Upper Trishuli-1 HEP (216MW)

DOOSAN NEPAL BRANCH OFFICE	Address & Contact No. : Four Square Building, Naxal, Kathmandu, Nepal (P.O Box : 1387) + 977 1 692 3014	Project No. H20002	DOCUMENT DISPATCHED BY Courier Service ☐ Messenger ☐ Post-Air Freight ☐ Document System or E-mail ■ By hand ■
DOCUMENT DISTRIBUTION	■ POWER CHINA (Subcontractor) ☐ Doosan's Site Office		
SUBJECT	Submission of Review Note RN-0200, RN-0201 and RN-0202

REVIEW NOTE

Contractor	**Doosan Enerbility**		
Title of the Document	Excavation and Support Drawings of Tailrace Outlet GC		
Document No.	UT1-C-080-CVL-DG-59001	Revision	0C
Date of Documents	27.07.2022	Received Date	27.07.2022
Transmittal Form No.	UT1-HEP-DHI-D-0317		
Previous Review Date/Status	10.07.2022/RR	Prev. Review Note No.	RN-0164
Review Note No.	**RN-0201**	**Present Review Date**	**28.07.2022**
		Present Review Status	**AN**

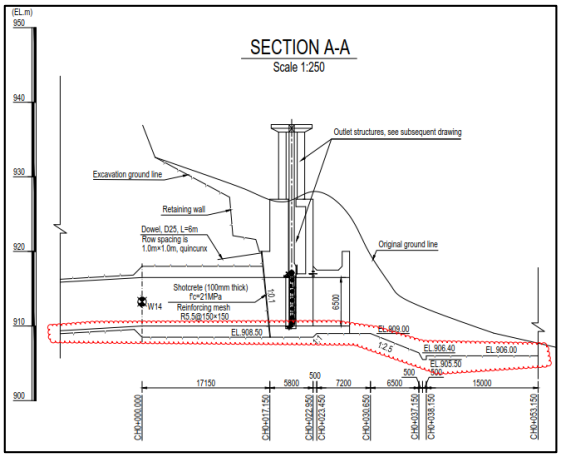
4. On sheet 2 of 2 of the drawing under this revision, in section A-A rock line is indicated beneath the Tailrace Outlet Gate Structure. This implies that the Tailrace Outlet Gate Structure will be founded on rock, see sketch below.
